RS-21-045

LaSalle County Station, Units 1 and 2  
Renewed Facility Operating License Nos. NPF-11 and NPF-18  
NRC Docket Nos. 50-373 and 50-374

Subject: Response to Request For Additional Information (RAI) Regarding Request For License Amendment Regarding Ultimate Heat Sink (EPID-L-2020-LLA-0165)

**Figure 7 from Reference 1**

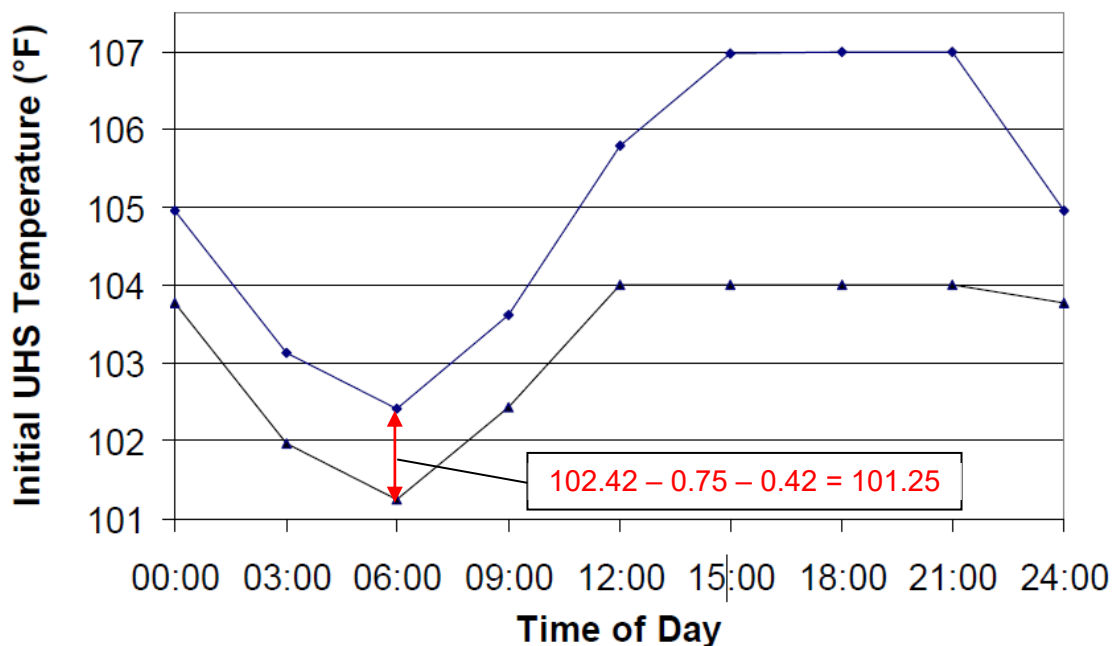
Provide the technical basis for the proposed values used to calculate the limits for the peak initial UHS temperature. Specifically, discuss how the reduction in "additional margin" used to calculate the peak initial UHS temperature is sufficient to ensure the maximum temperatures do not exceed the safety analysis limit and justify the reduction of margin from 0.42°F to 0.25°F.

The proposed diurnal curve is derived by taking the temperature limit of 107°F and subtracting the instrument uncertainty and a discretionary additional margin of 0.25°F.

The current 0.42°F of additional margin was added to reference the most limiting initial UHS temperature in the existing diurnal curve to the previous Technical Specification 3.7.3, "Ultimate Heat Sink," temperature limit of 101.25°F as described in Reference 1.

The results of analyses performed at worst case synthetic weather conditions identified the maximum initial water temperatures that would result in a peak UHS water temperature of 107°F. The most restrictive initial temperature for silt levels at 18 inches was 102.42°F starting at 06:00 in the morning. This temperature value was referenced to the past Technical Specifications (TS) peak lake temperature limit of 101.25°F which was in effect prior to approval

of the existing diurnal curve implemented through Reference 2. Instrument uncertainty for the Circulating Water (CW) inlet temperature instruments is 0.75°F.

Therefore, Additional Margin =  $102.42 - 101.25 - 0.75 = 0.42^{\circ}\text{F}$ .

The additional discretionary margin of 0.42°F, while not required, was included to provide added conservatism to the overall temperature limitations of the diurnal curve. The value of 0.42°F was subtracted from the most limiting initial UHS temperature after the analysis was performed for the determination of the peak initial temperatures which would result in a maximum UHS temperature of 107°F. An operationally convenient discretionary 0.25°F adjustment factor, or margin, was used in generating the proposed TS Figure 3.7.3-1 in Reference 3 for the 6 inch siltation level to ensure that the peak initial UHS temperature does not exceed 106°F which is the highest evaluated temperature for non-safety related systems.

For this reason, the change in the additional margin of 0.42°F to 0.25°F will not impact the results of the original analysis. The current instrument uncertainty provides sufficient margin to conservatively monitor UHS temperature without the risk of inadvertently exceeding the maximum UHS temperature of 107°F.
